Tuen Mun - Chek Lap Kok Link
Northern Connection Sub-sea Tunnel Section
Contract No. HY/2012/08

T	M	C	L	K	L	8	-	D	B	J	-	G	E	N	-	R	E	P	-	9	8	7	4	5	A	IFA		
Project Ref. Num.								Issuer				Location				Doc. Type					Doc. Sequential. Num.					Rev.	Status.

Environmental Assessment
Changes in Dredging Extent of Northern Landfall

Figure 1 Latest Construction Sequence

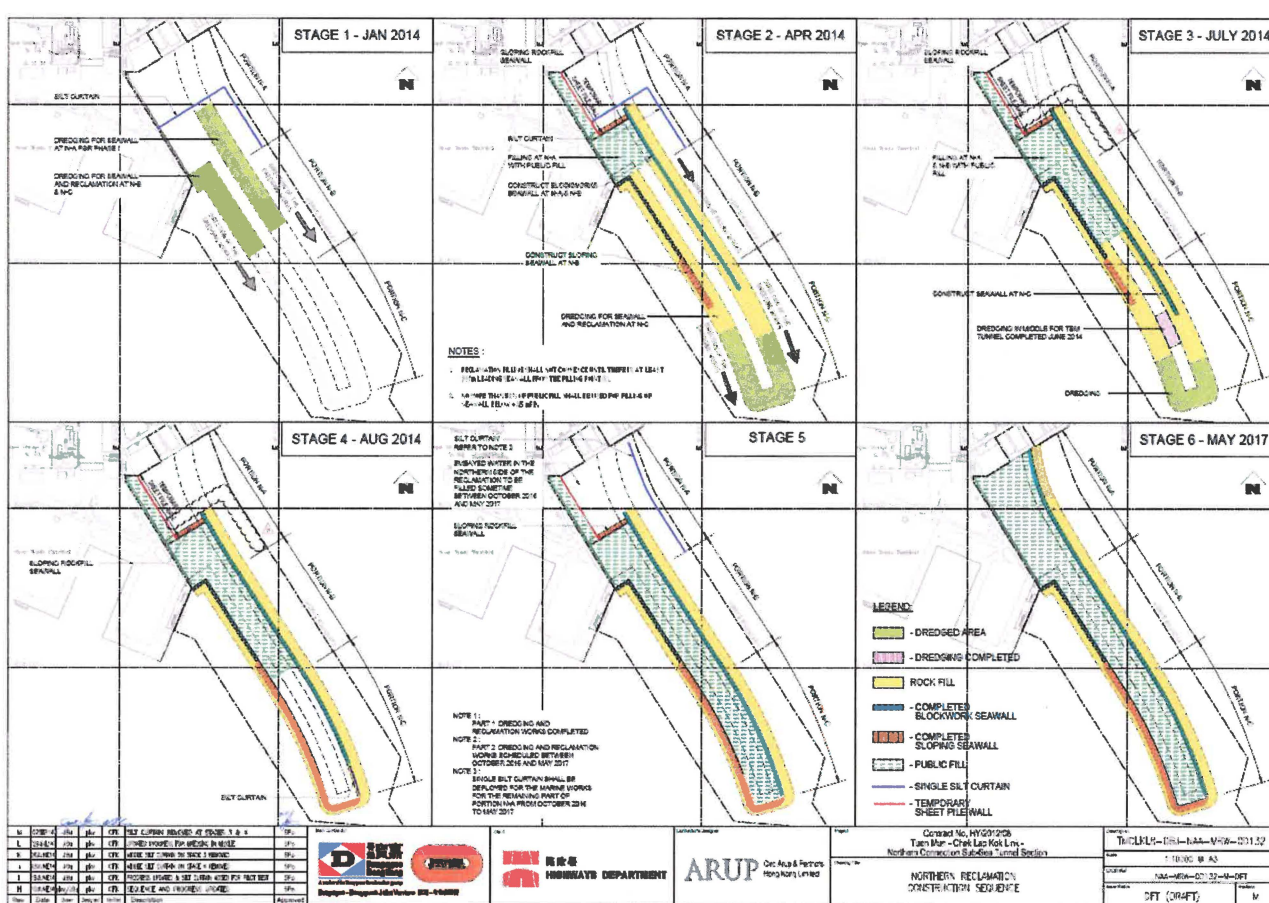
Pursuant to Condition 3.5 of the Environmental Permit EP-354/2009/B, we hereby give written notice that, due to changes in progress and methodology, “dredging in the middle” at Portions N-A and N-B, as specified under Condition 3.7(d) and Figure 3 of the EP-354/2009/B is no longer necessary. The latest construction sequence is illustrated in Figure 1 and Appendix A.

It is proposed that the dredging in the middle of Portion N-A and Portion N-B to be deleted. The additional dredging in the middle of Portions N-A and N-B, as stated under VEP application (VEP-426/2014) and subsequently approved in the EP-354/2009/B, was intended to resolve buoyancy pressure of marine mud acting upon the TBM assembly, as well as other geotechnical and structural limitations.

An alternative solution of ground treatment will be implemented to speed up consolidation of the Northern Landfall, so that the TBM may safely drill through it. This solution involves the use of vibrocores. This method employs large vibrating rod, which vibrates into the ground to compact the wet soil. In the process, additional sand is pulled down to the ground, filling voids and forming compacted land. Once the land is compacted, drilling rigs will plow/drill into the ground at strategic locations to inject and mix cement grout into the soil. This will further bind the fill material and solidify the grounds to provide a stabilized substrate for the TBM to drill through, avoiding buoyant pressure acting upwards on the TBM unit.

The ground treatment works is land-based. It replaces the marine dredging works in the middle of Portions N-A and N-B and is carried out on top of the completed parts of the Northern Landfall reclamation. Therefore, it is considered that the reclamation method, as considered under the EIA assumption, will not change as a consequence of the proposed changes.

Drawing Title
NORTHERN RECLAMATION
CONSTRUCTION SEQUENCE

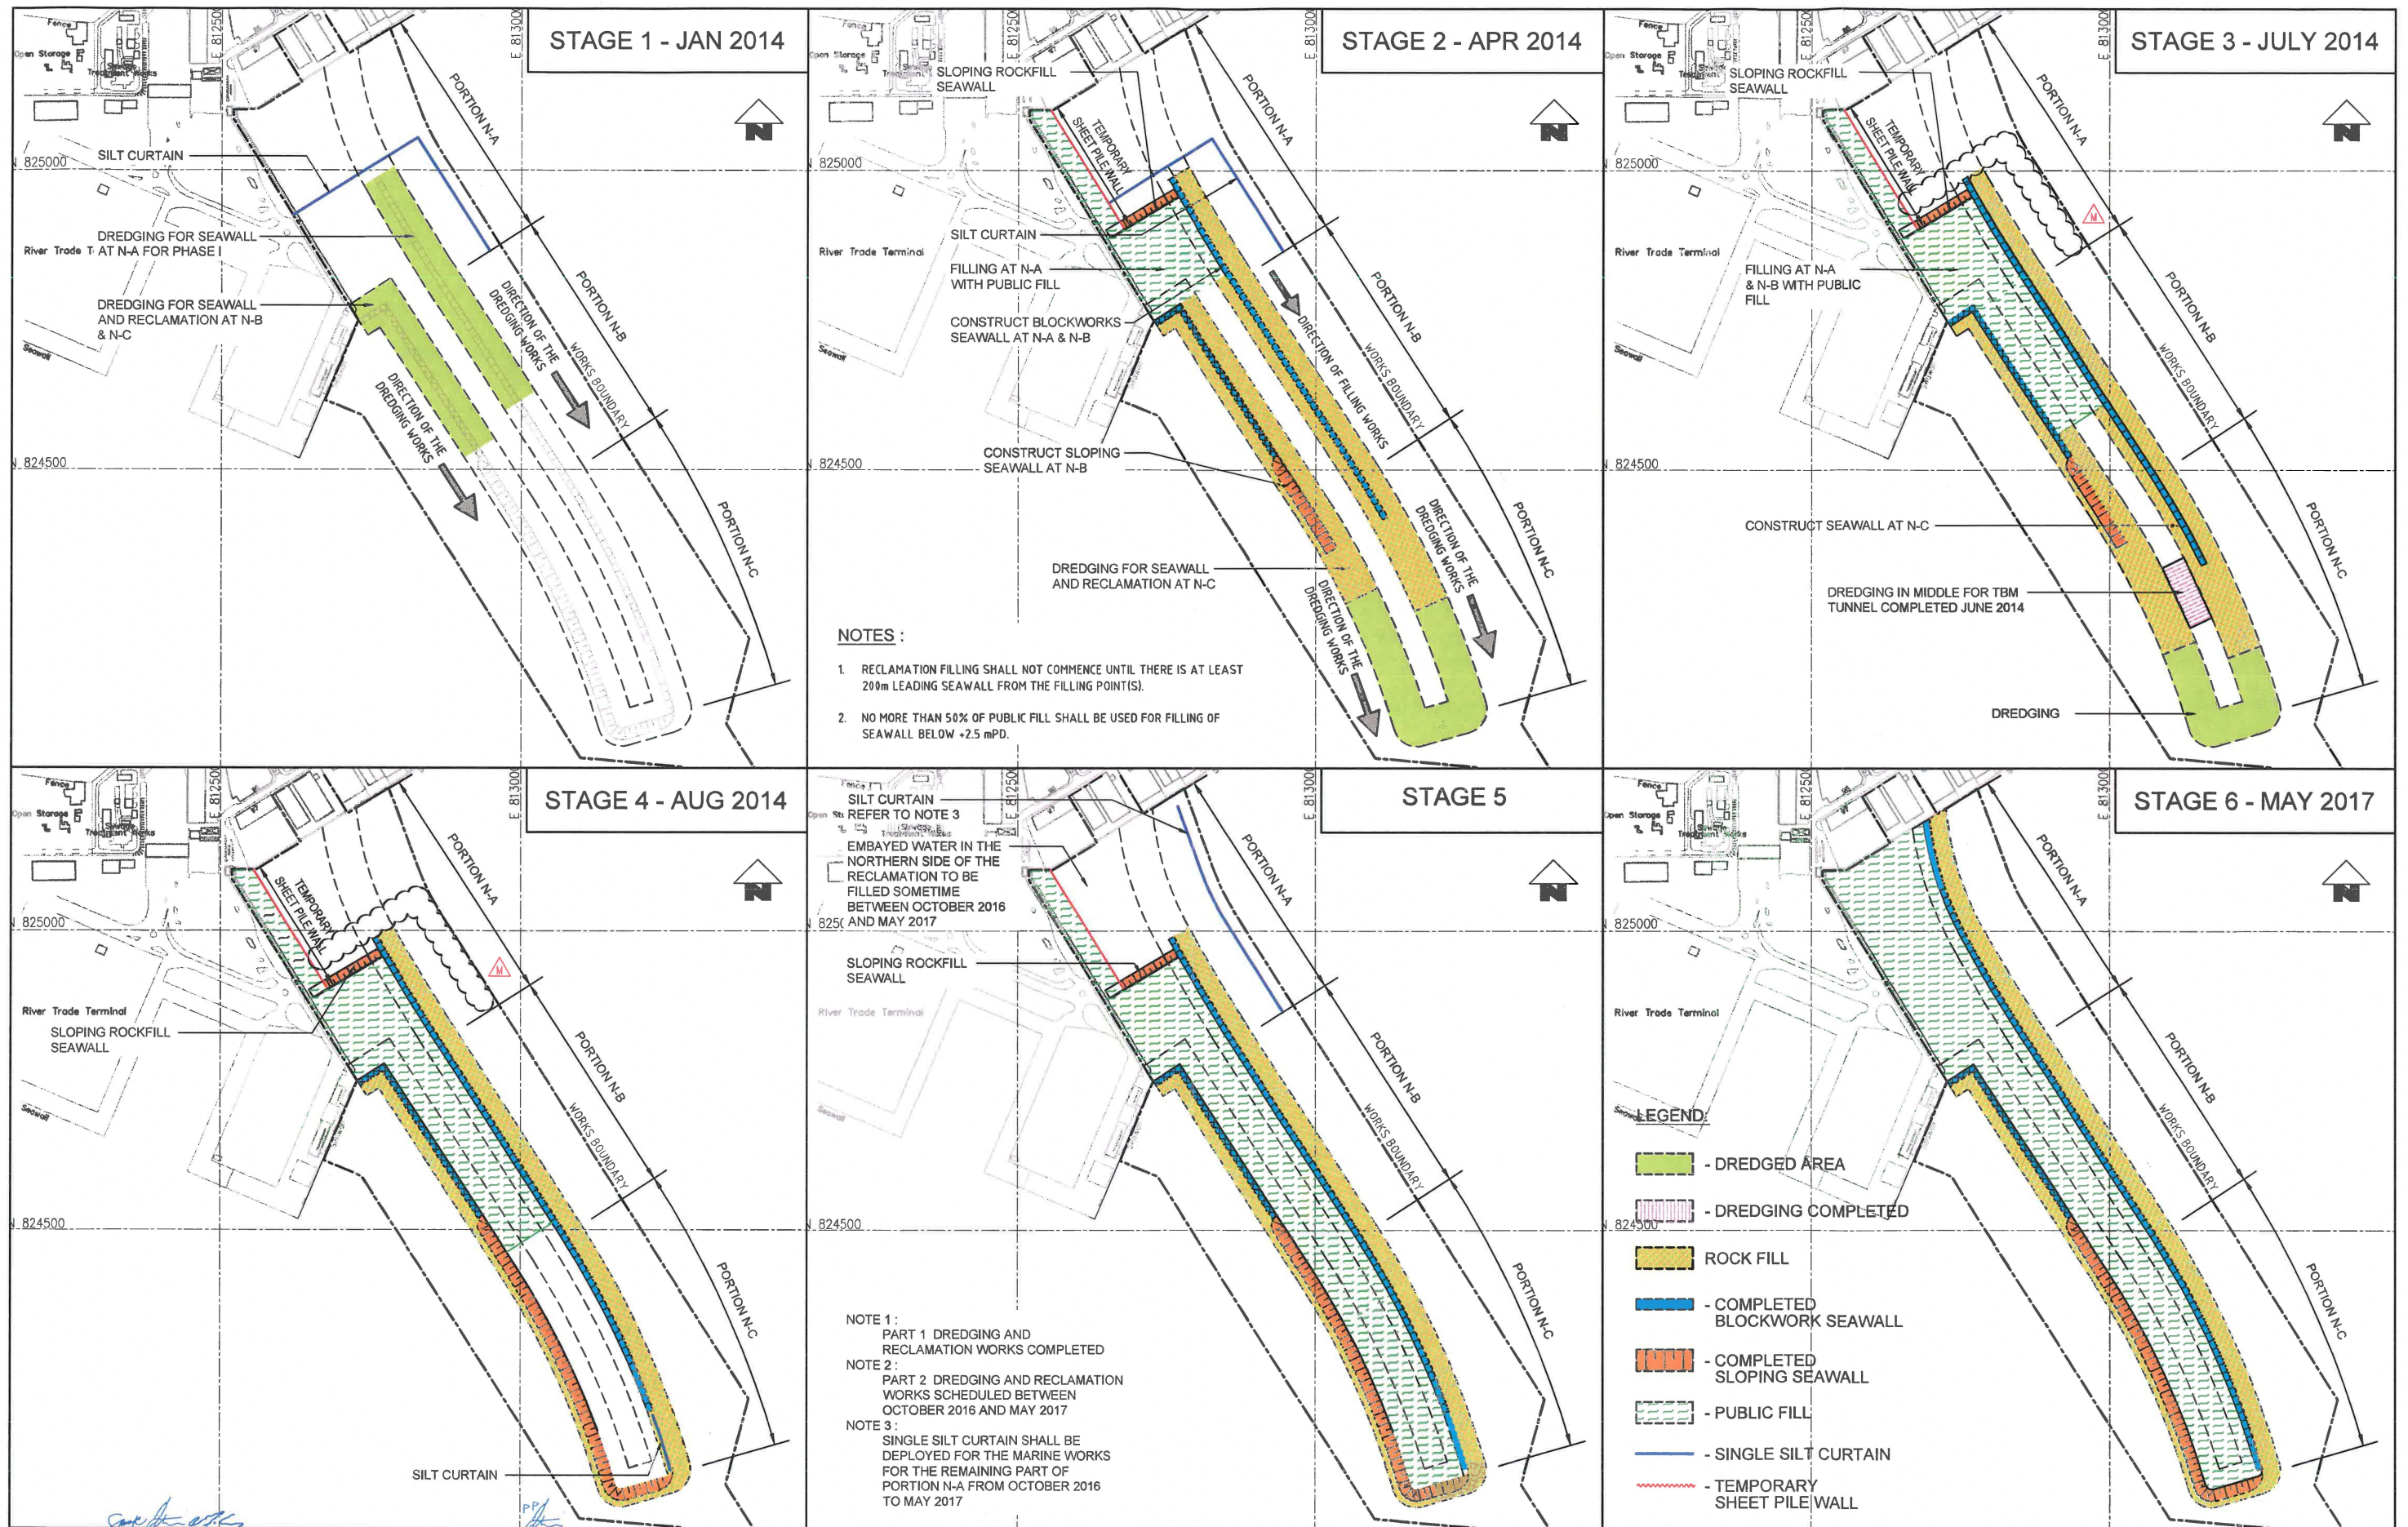
M	02SEP14	JBu	plv	CFK	SILT CURTAIN REMOVED AT STAGES 3 & 4	SPo
L	09JUL14	JBu	plv	CFK	UPDATED PROGRESS FOR DREDGING IN MIDDLE	SPo
K	26JUNE14	JBu	plv	CFK	MIDDLE SILT CURTAIN ON STAGE 3 REMOVED	SPo
J	23JUNE14	JBu	plv	CFK	MIDDLE SILT CURTAIN ON STAGE 4 REMOVED	SPo
I	19JUNE14	JBu	plv	CFK	PROGRESS UPDATED & SILT CURTAIN ADDED FOR PILOT TEST	SPo
H	10JUNE14	plv/JBu	plv	CFK	SEQUENCE AND PROGRESS UPDATED	SPo
Rev.	Date	Drawn	Designed	Verified	Description	Approved
